# Product Change Notification

## 113545 - 00

**Change Notification #:** 113545 - 00  
**Change Title:** Intel® I/O Module Carrier Kit AXXKPTPIOM  
PCN 113545-00, Product Design  
Update the Gasket  
**Date of Publication:** December 23, 2014

**Figure 1. Dimension Change of the Gasket**

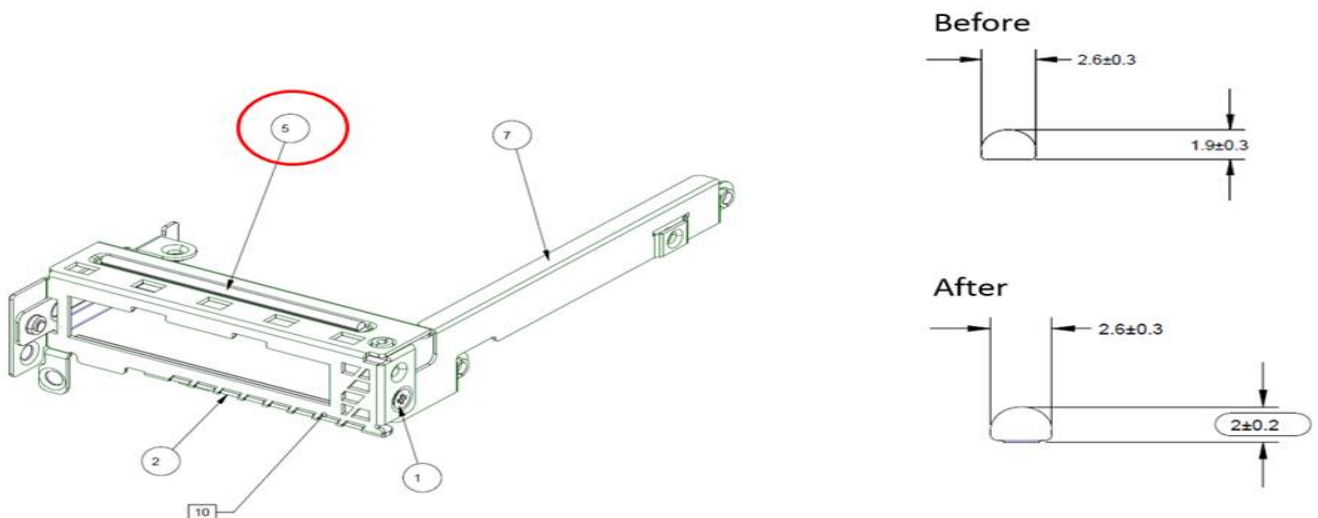
1. Intel has implemented the following change on Intel® I/O Module Carrier Kit AXXKPTPIOM:

Increase the height of the gasket on top of the I/O module carrier bracket from  $1.9\pm 0.3$  mm to  $2.0\pm 0.2$  mm for better ESD (Electrostatic Discharge) protection (see Figure 1).
